# Access Compliance Report

## Public Rights-of-Way

Intersection ID: N/A	Main Street: S COLLEGE ST	Cross Street: E HILL ST	Location: S
ADA ID: 2EF8E69517C1	Ramp Type: Perp	Initial Pass/Fail: Pass	Overall Compliance: No
			Severity Score: 2.75

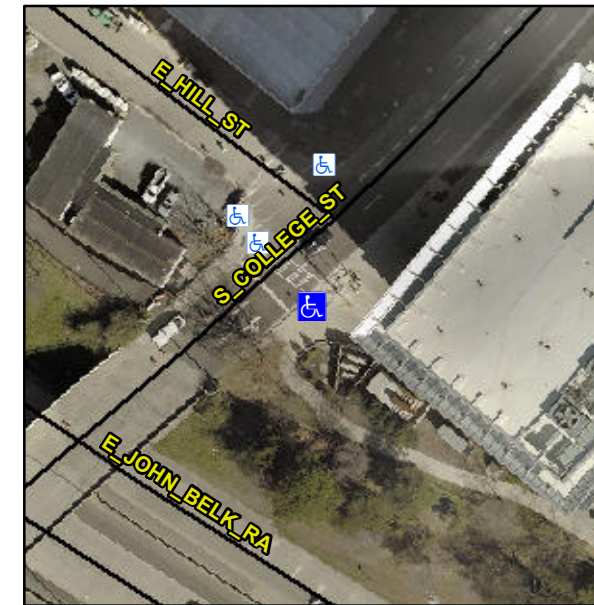
**Not Found, R304.2.3, R304.5.3**

Compliance	Description	Data	Compliance	Description	Data
N/A	Ramp Length (in)	96.0	Yes	Ramp Slope (%)	5.4
Yes	Ramp Width (in)	59.5	Yes	Ramp XSlope (%)	3.1
N/A	Flare Type LT	Sloped	N/A	Flare Type RT	N/A
N/A	Flare Slope LT (%)	4.7	No	Flare Slope RT (%)	10.7
N/A	Flare Traversable LT?	Yes	N/A	Flare Traversable RT?	Yes
Yes	Landing Length (in)	51.0	Yes	DWS Provided?	Yes
Yes	Landing Width (in)	59.0	Yes	DWS Contrast?	Yes
Yes	Landing Slope (%)	1.4	Yes	DWS Length (in)	24.0
Yes	Landing X Slope (%)	1.7	Yes	DWS Full Width?	Yes
N/A	Landing Curb? (Y/N)	No	Yes	DWS Offset (in)	0.0
N/A	Shared Landing?	No			
Yes	Gutter Ponding?	No	Yes	Gutter Slope (%)	0.8
Yes	Gutter Lip Ht (in)	0.0	No	Gutter X Slope (%)	5.2
N/A	Painted X Walk1?	Yes	N/A	Painted X Walk2?	N/A
	X Walk 1 Direction	To N		X Walk 2 Direction	N/A
N/A	X Walk 1 Width (in)	105.0	N/A	X Walk 2 Width (in)	N/A
	X Walk 1 Slope (%)	0.6		X Walk 2 Slope (%)	N/A
	X Walk 1 X Slope (%)	4.6		X Walk 2 X Slope (%)	N/A

**Remove & Replace Entire Ramp.  
Remove & Replace Gutter.**
